# Staff Report

Re: PLNPCM2021-00503 The June, 624 and 636 South 300 West

## Design Review

**REQUEST:** A request by Jason Malaska of CW Urban for Design Review at approximately 624 & 636 South 300 West. The proposal is to construct a new multifamily residential building. The proposed building will have 102 units with a mix of studio, 1 bedroom, 2 bedroom, and penthouse units. The building will have two podium parking levels with 100 parking stalls and five levels of apartment units above. The project site is in the D-2 (Downtown Support) zoning district. The applicant is requesting Design Review to allow for building height of 85'.

LEVEL 1/ SITE PLAN

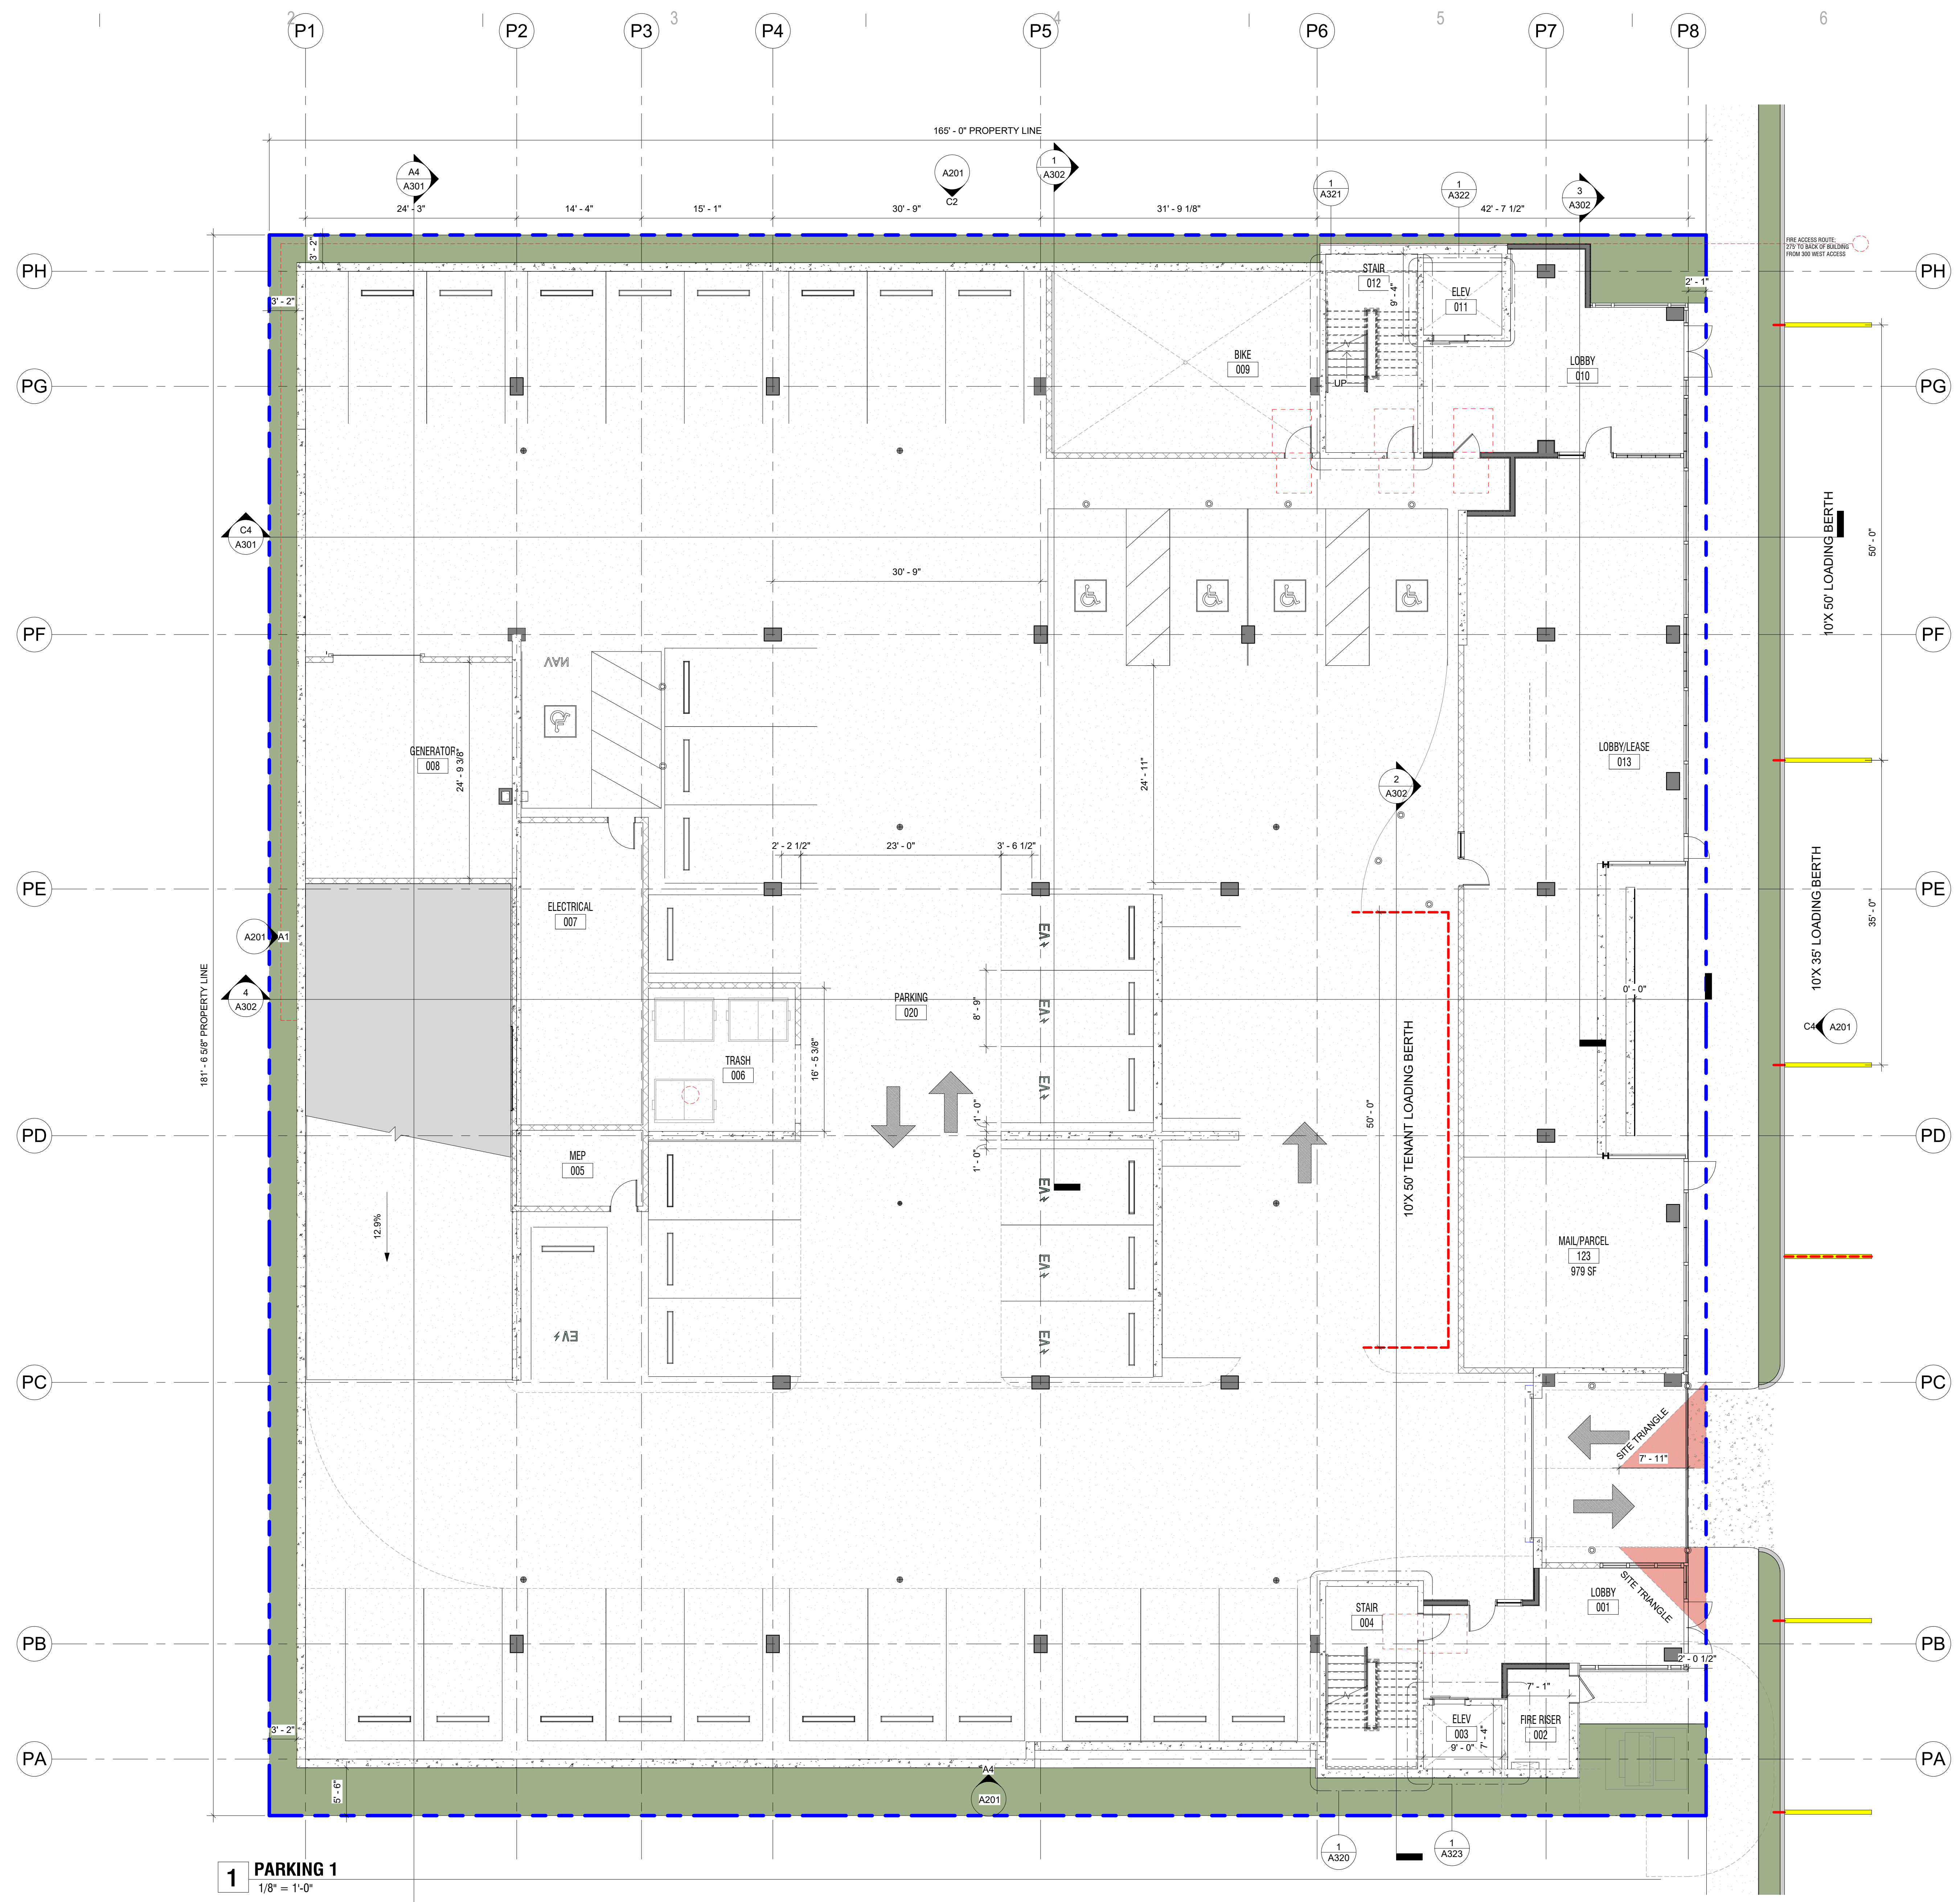
- Site plan shows approximately 3' setback on rear and north side yards; Engineering plan shows the building going to the property line. Please clarify the setbacks.

- The 21A.37 responses state that the mechanical equipment is located in the garage. What equipment will be located in the garage? The site plan identifies a transformer proposed south of the building. Identify if there will be screening for it. The site plan also identifies that there are to be rooftop condensing units hidden behind a parapet. Identify the height of the parapet. Please identify if there is additional mechanical equipment.

EXTERIOR ELEVATIONS

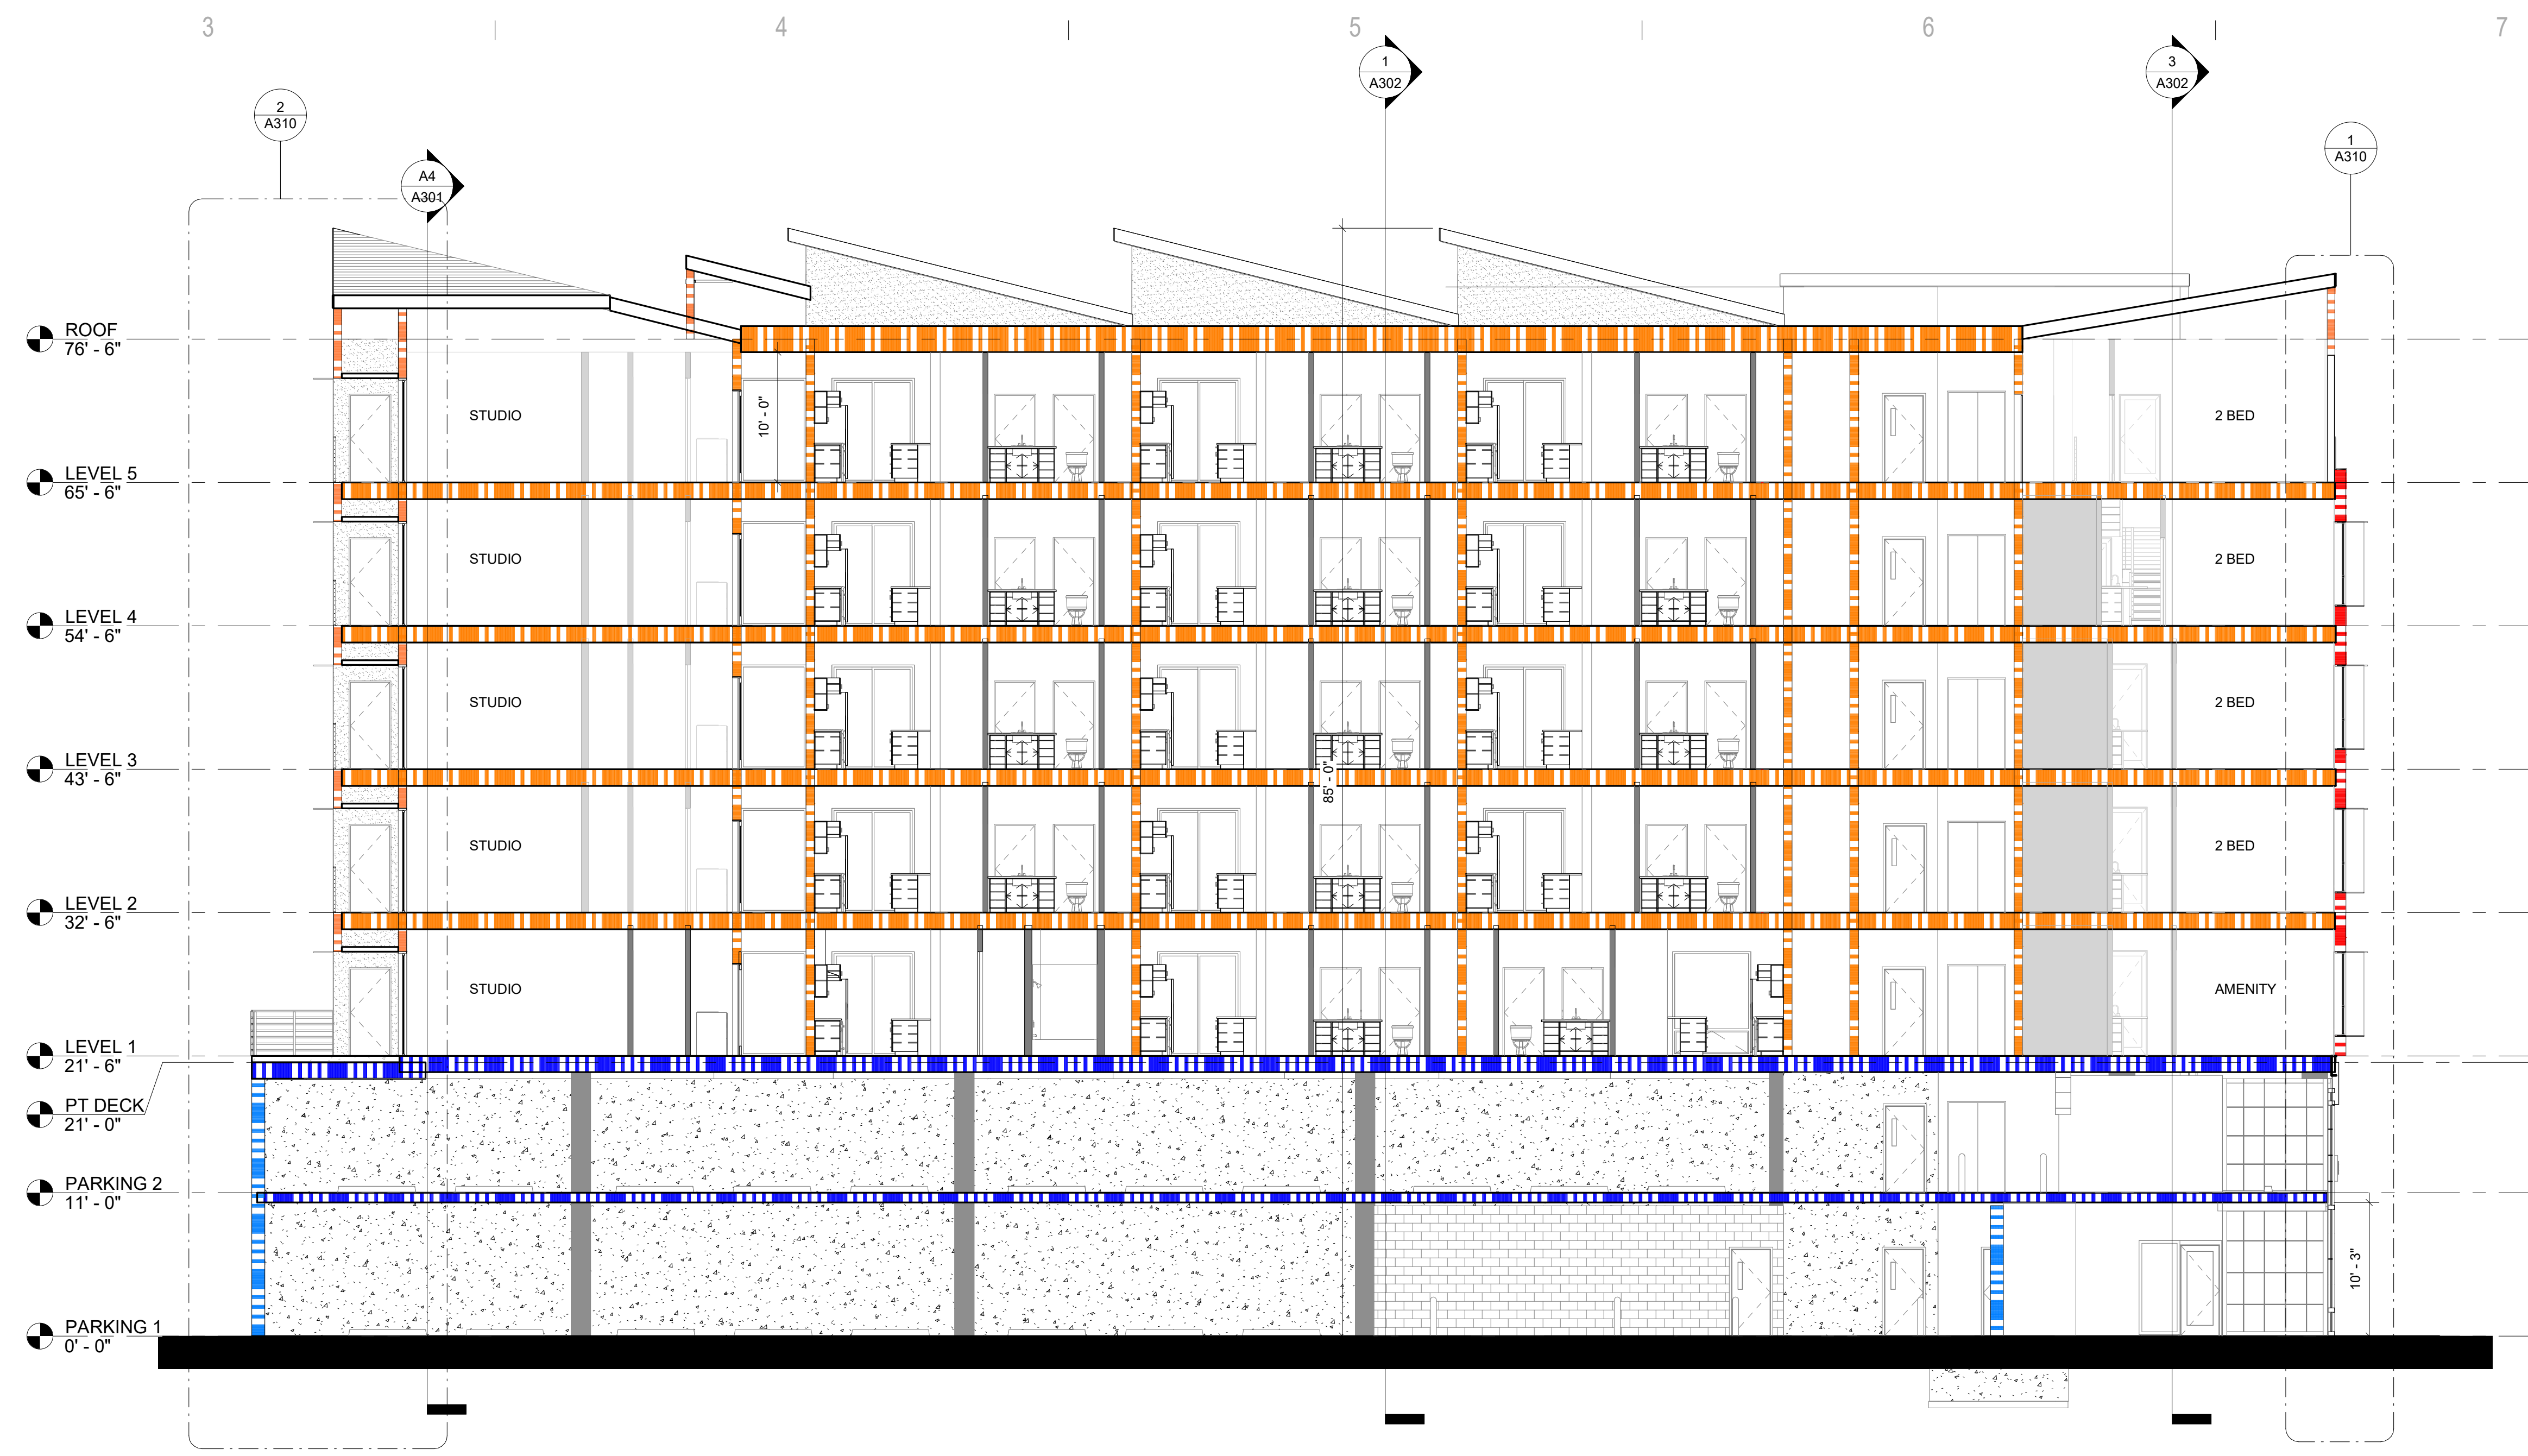
proposal. The D-2 zoning district permits 65' by right and up to 120' with Design Review. The applicant is requesting Design Review to allow for additional building height of 85', which is the peak of the sloped area of the roof and the stair and elevator towers.

The underlying D-2 zoning district allows for an increase in building height from 65' to a maximum 120' with a Design Review and a determination by the Planning Commission. The applicant is requesting a height of 85'.

The building has a maximum height of approximately 85'. The maximum height permitted in the D-2 zoning district, which applies to the properties to the east, north and south, is 65' by right and 120' is permitted with Design Review. The property to the west is in the CG (General Commercial) zoning district where 60' is permitted by right and 90' is permitted with Design Review.
